SAMPLING AND ANALYSIS PLAN FOR THE SITE CHARACTERIZATION OF THE 903 DRUM STORAGE AREA (IHSS 112), 903 LIP AREA (IHSS 155), AND AMERICIUM ZONE - JEL- 29-97

Final Sampling and Analysis Plan for the Characterization of the 903 Drum Storage Area, 903 Lip Area, and Americium Zone	Document Number Revision Date Page	RF/RMRS- 97-084 0 December 15, 1997 ES-1 of ES-2
---	---	---

***Sampling and Analysis Plan
for the
Site Characterization of the 903 Drum Storage Site
903 Lip Area, and Americium Zone***

Figure 3 2 Surface Soil Sampling Scheme

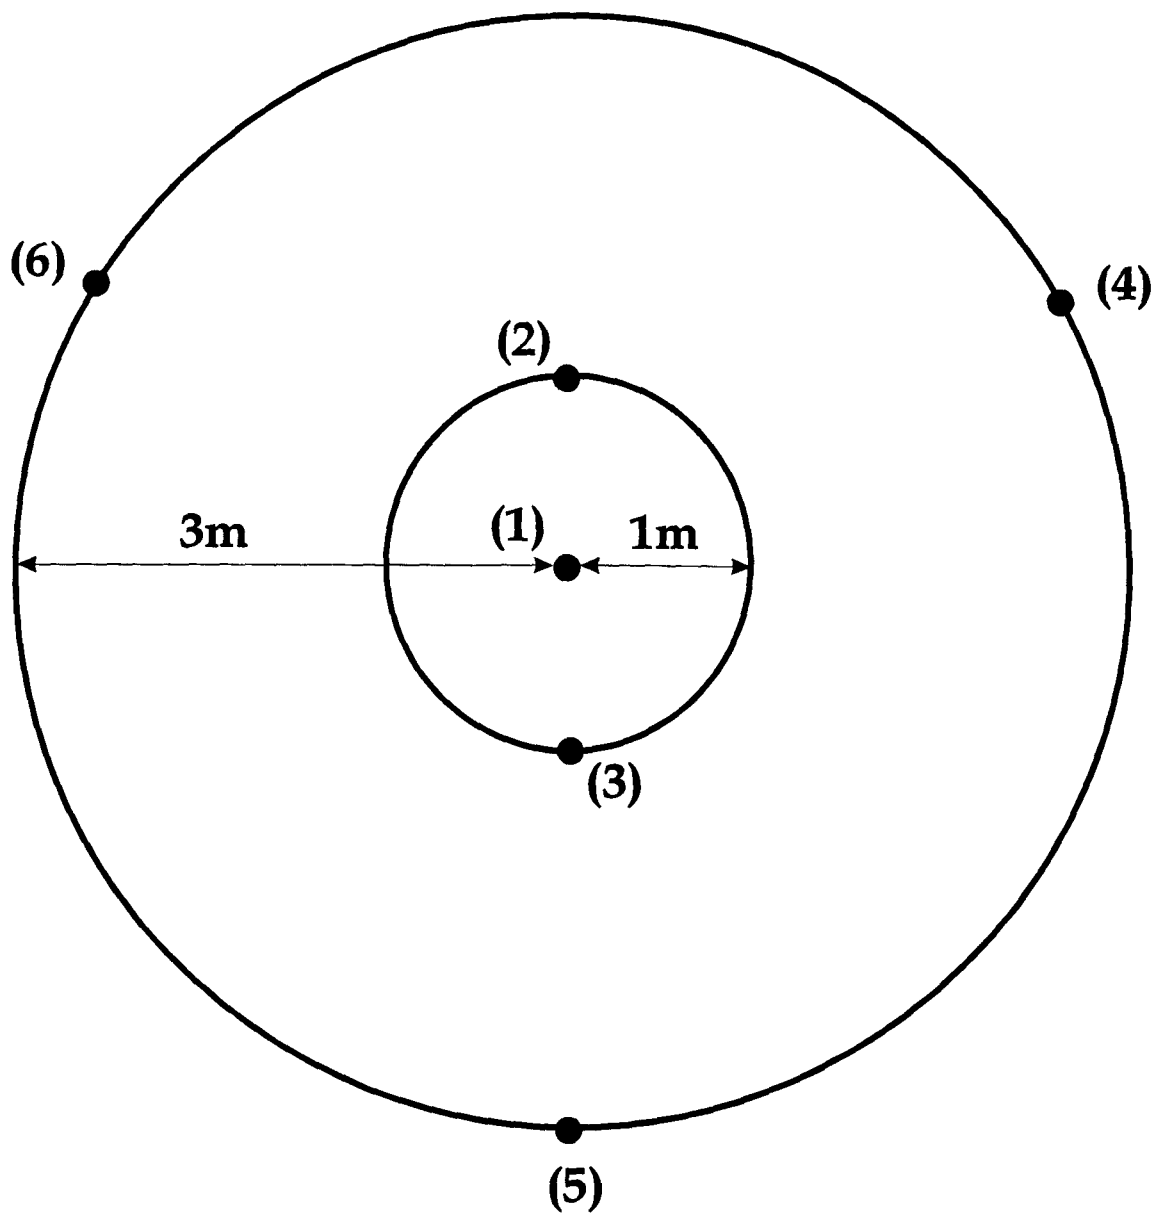
The last paragraph states that Figure 3 2 provides the "typical surface" soil sampling scheme for HPGe correlation sampling. Does this mean that all sampling points will mirror Figure 3 2? Please explain further.

Yes. The revised surface soil sampling scheme will be utilized at all sampling locations as proposed in Section 3 1 1 4 and shown on Figure 3 2.

Figure 3 3

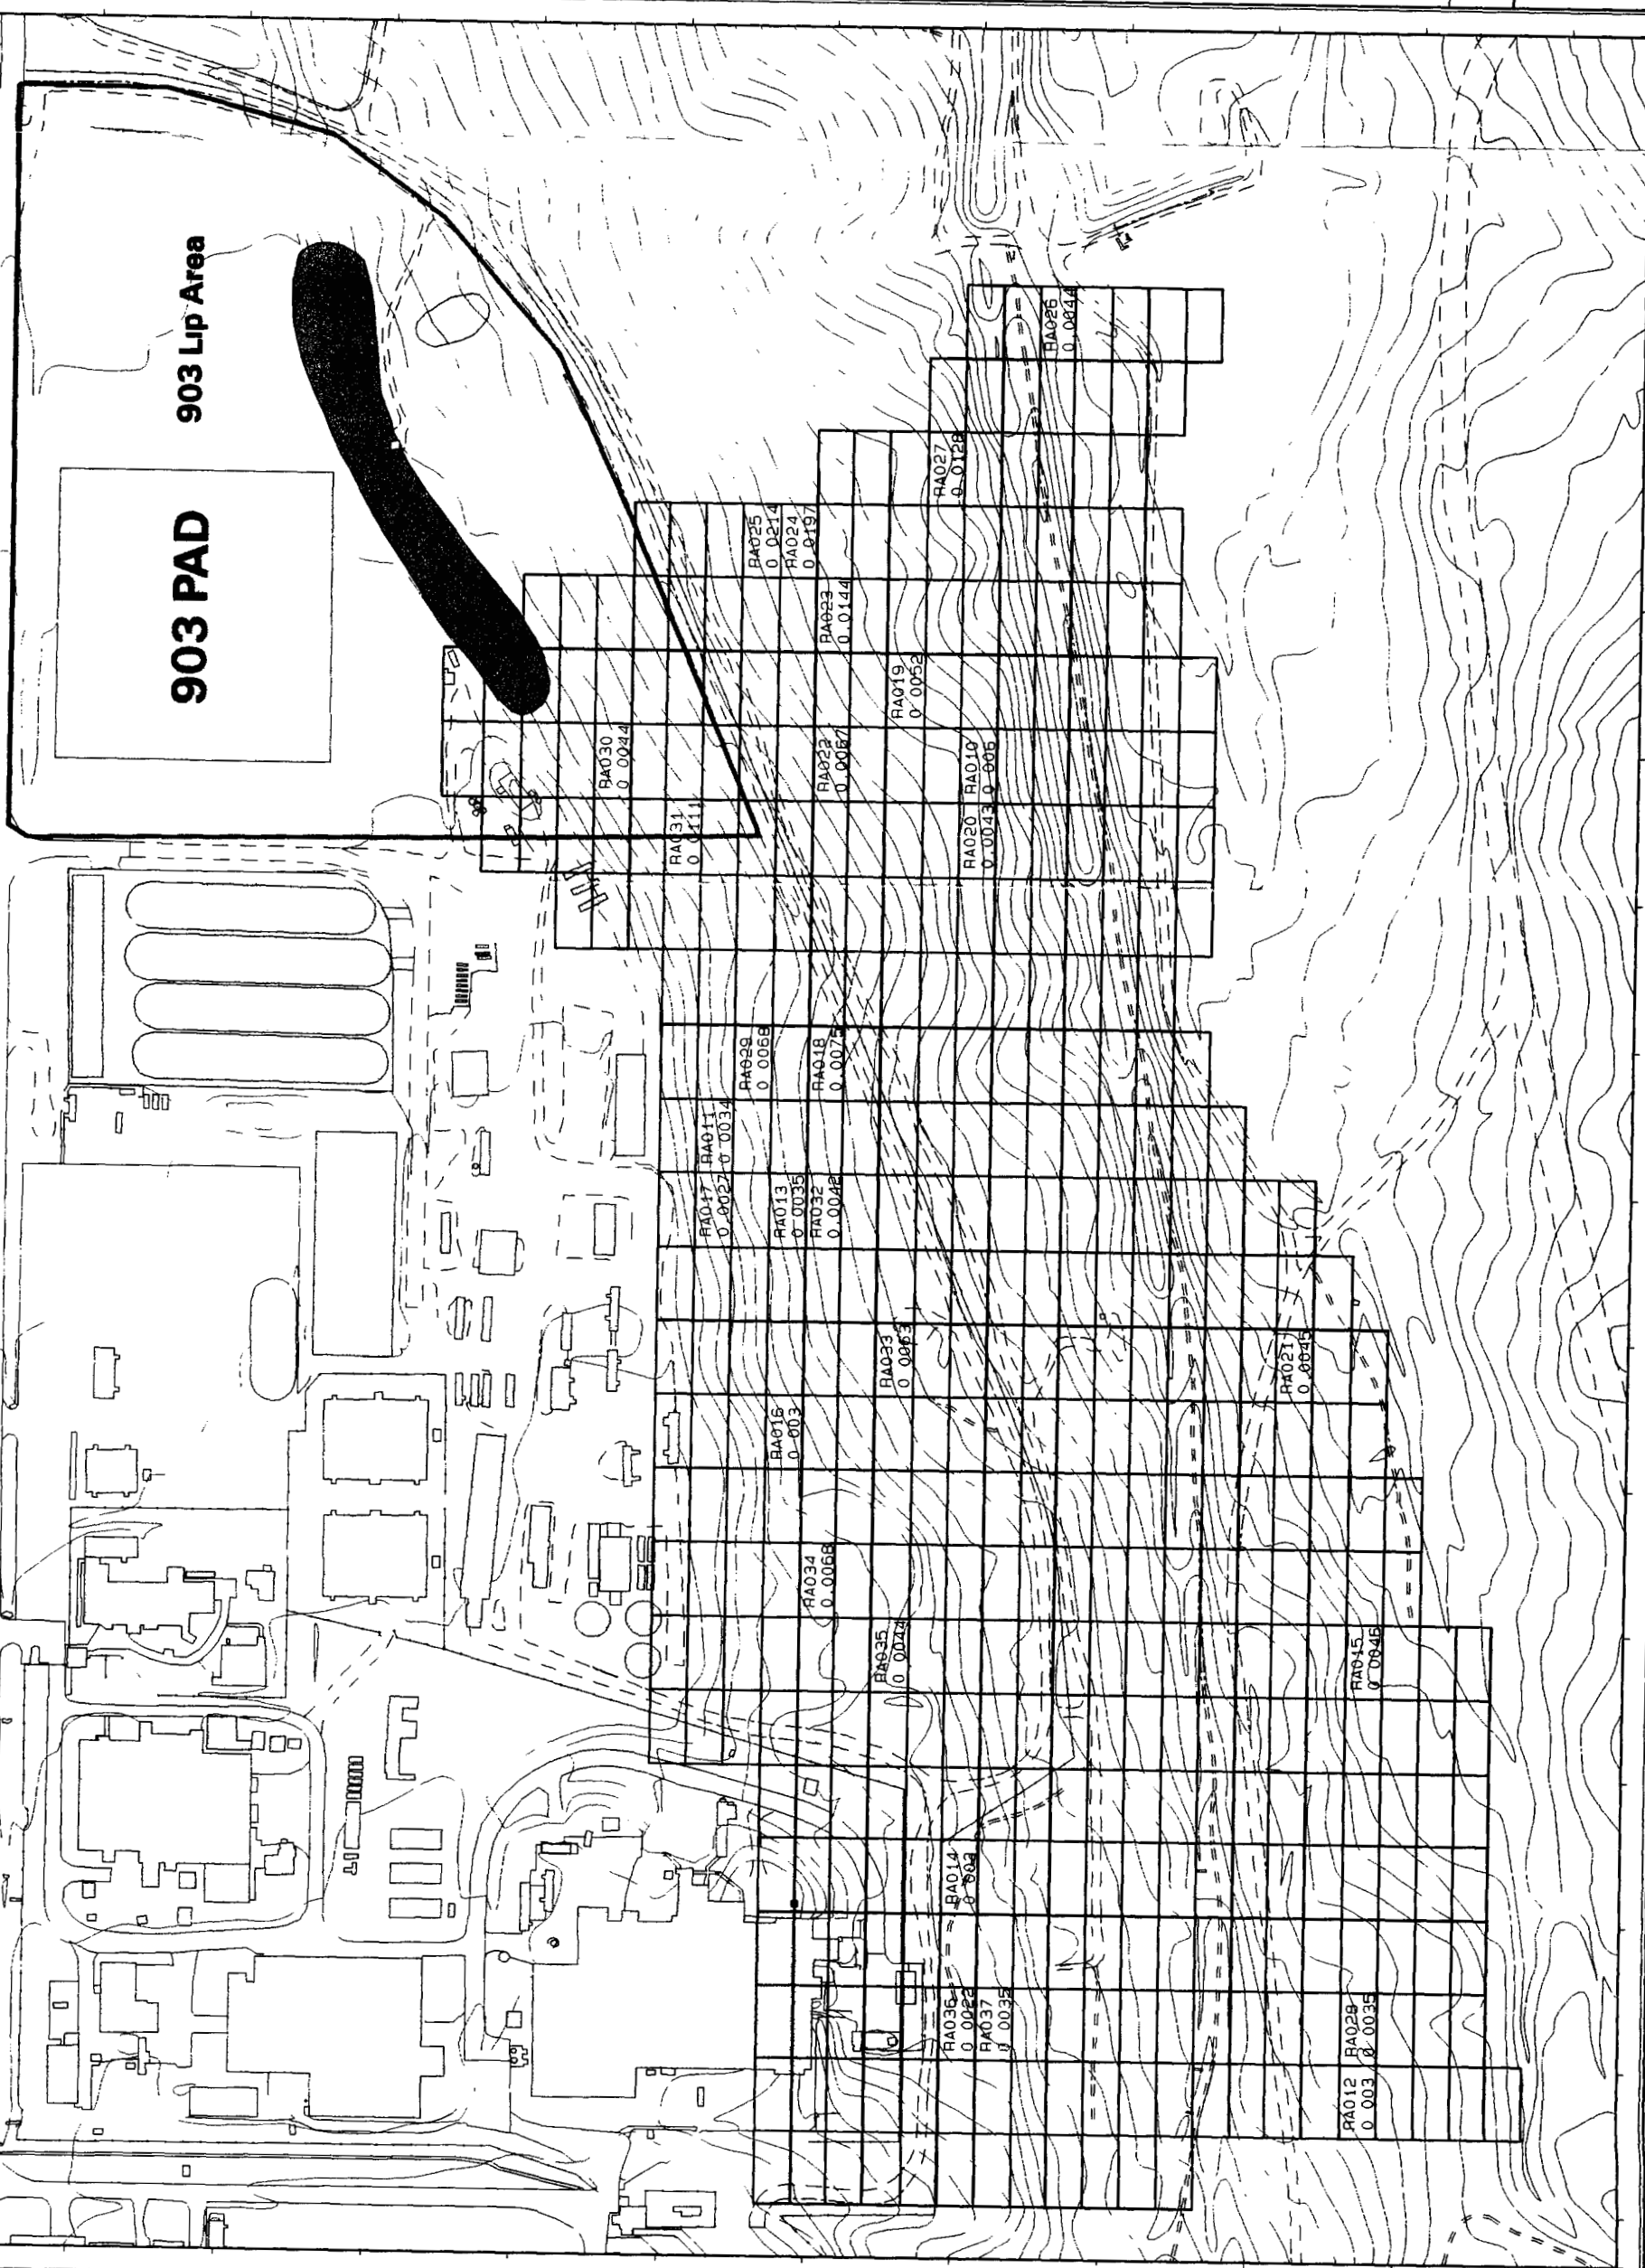
Page 21, Paragraph 1, Sentence 1 states that 21 boreholes are proposed to be completed over the Lip Area, however, sentence 3 states that 14 boreholes will be placed at each node of a 165' grid and Figure 3.3 includes 22 samples. Please explain this, and provide information to demonstrate this number will be representative

Figure 3 4

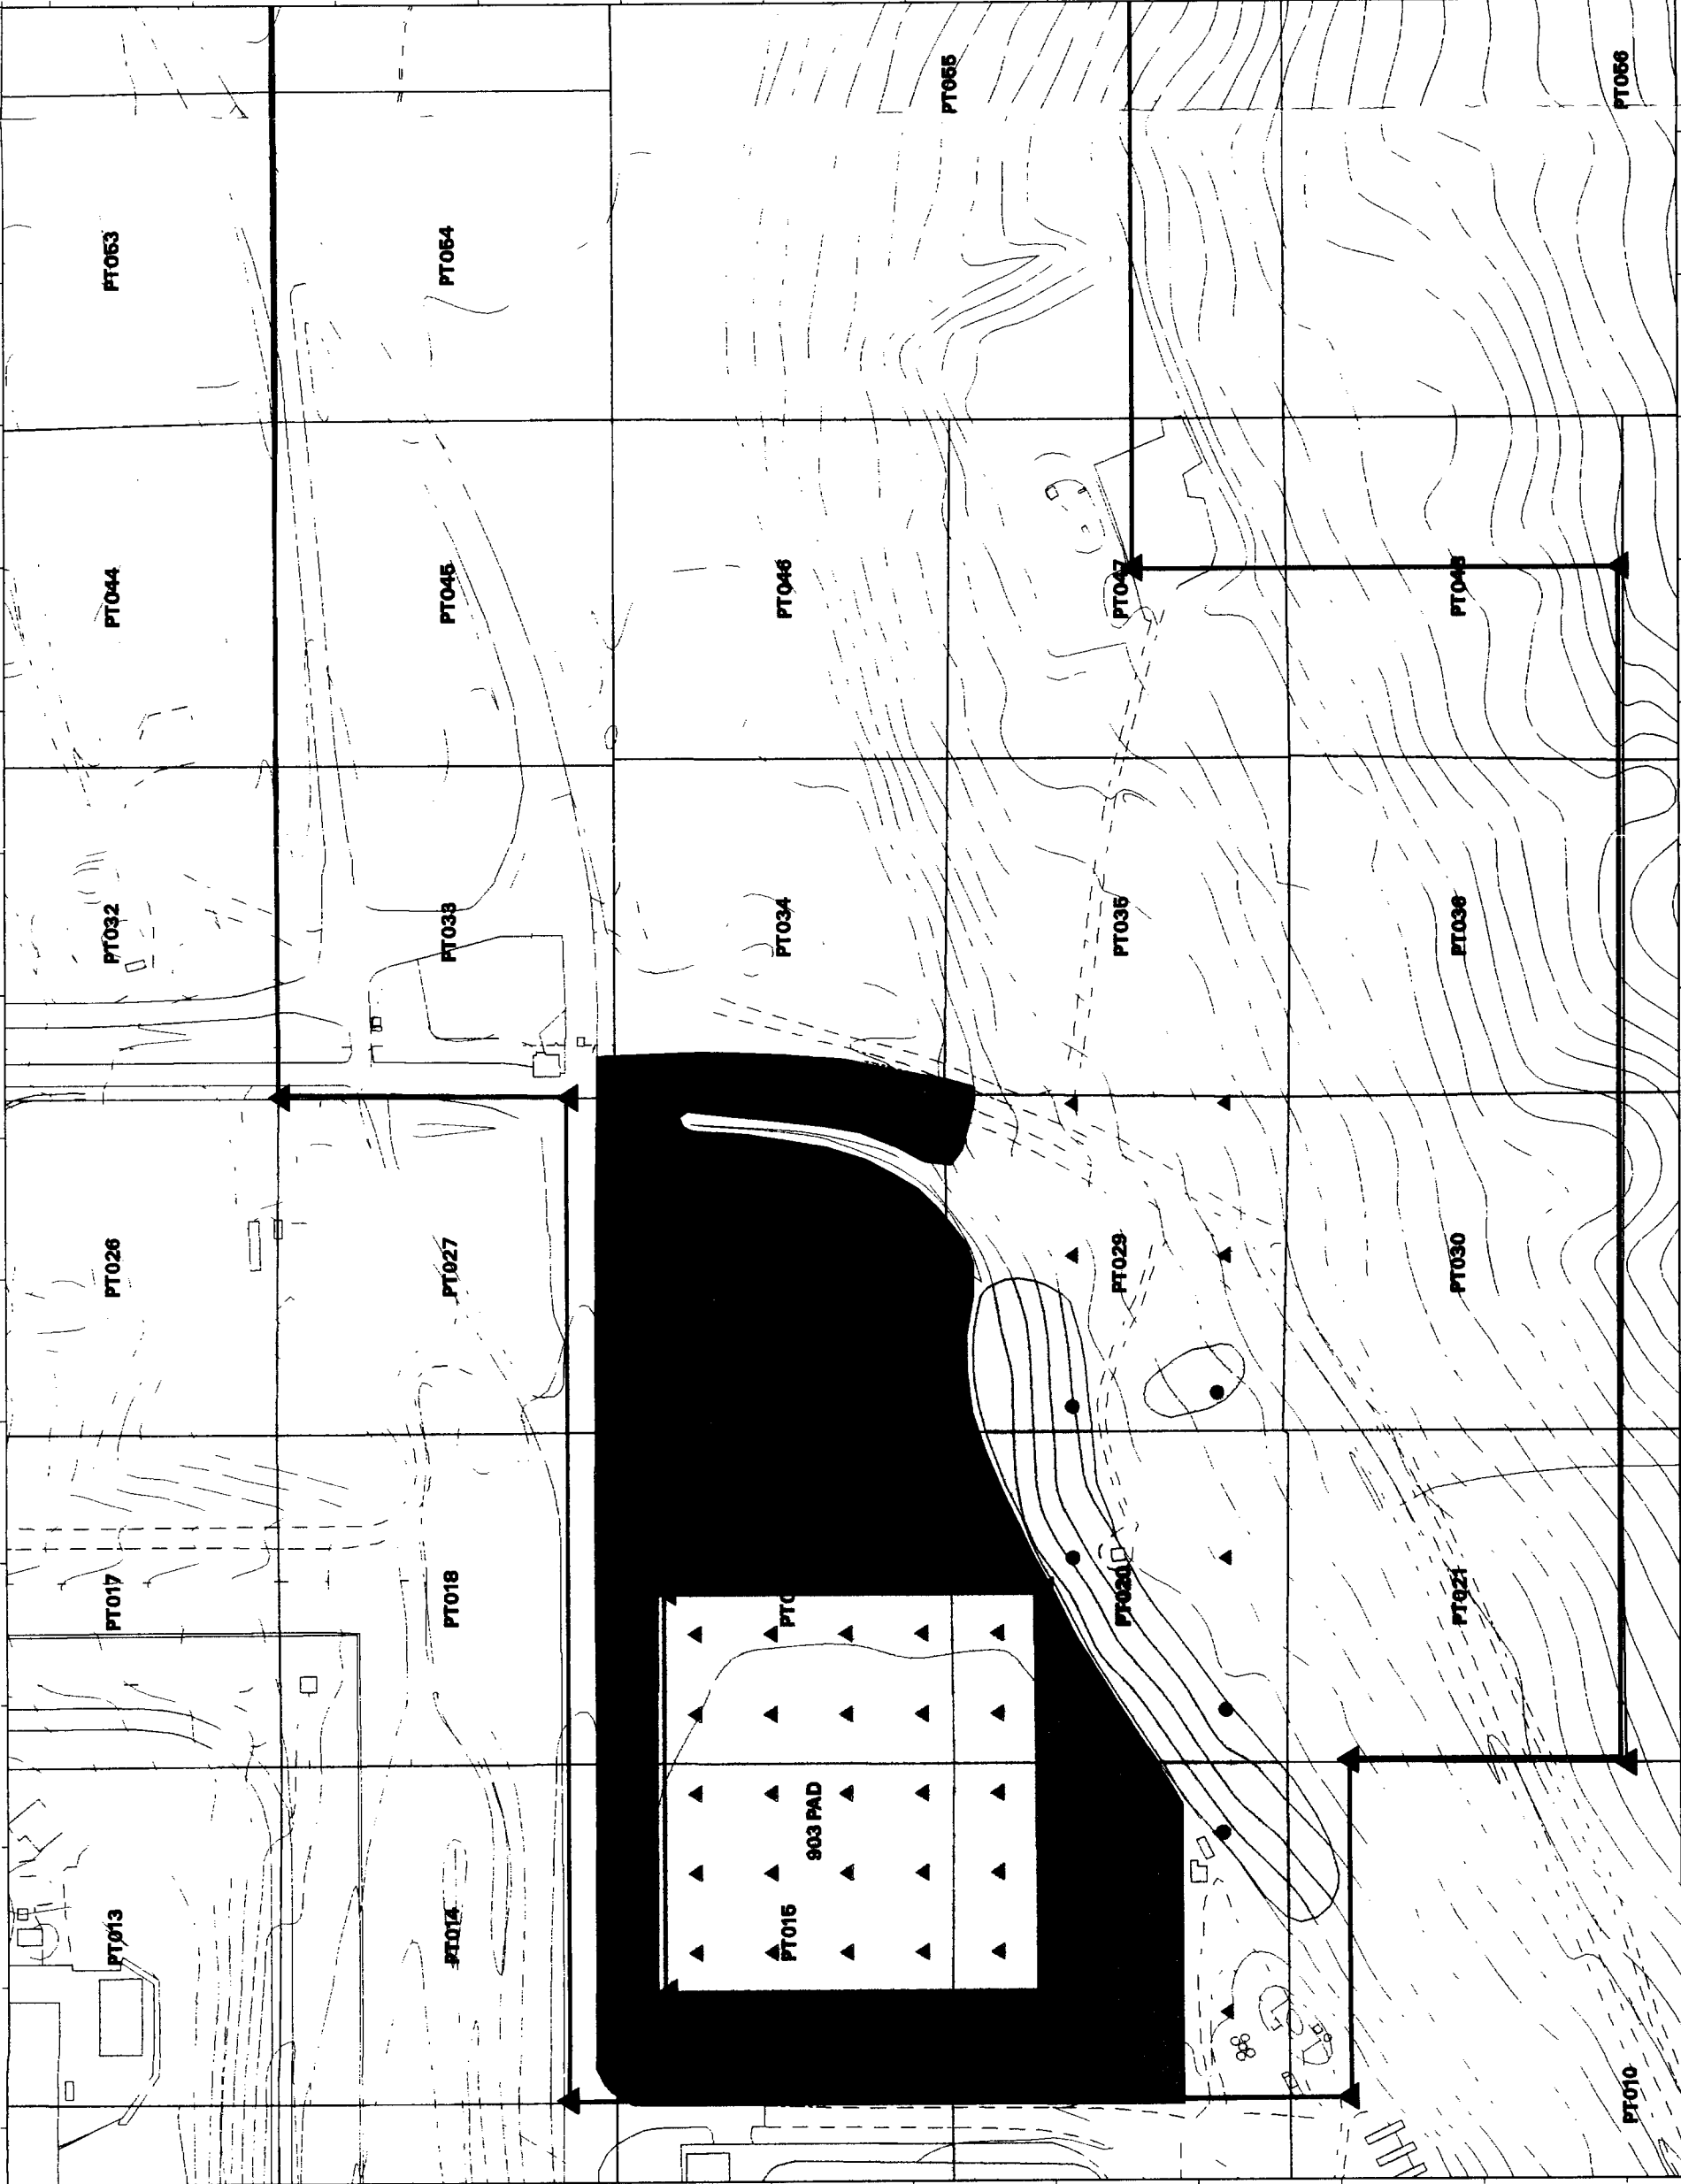
Last paragraph: This paragraph discusses borehole locations. A reference to Figure 3-4 would be useful.

Page 31, The Lip Area Section. The second paragraph describes fourteen boreholes which will be drilled. However, the specific locations which will be sampled is not clear from Figure 3-4.

Page 34 Figure 3-4, Please provide further details on this figure in relation to the 903 Pad, Lip and Americium Zone

The text has been revised to reference Figure 3.4.

Figure 3 4 shows one boring west of well 06691 The text has been revised to more clearly describe the methodology to be used for the VOC investigation The proposed radial geometry placement of boreholes for the VOC Investigation uses well 06691 as the center with one boring placed 20 feet to the north, south, west, and east Additional borings will be located radially based on the highest field readings or analytical results

Figure 3 4 has been revised to includes labels for the 903 Pad and 903 Lip Area
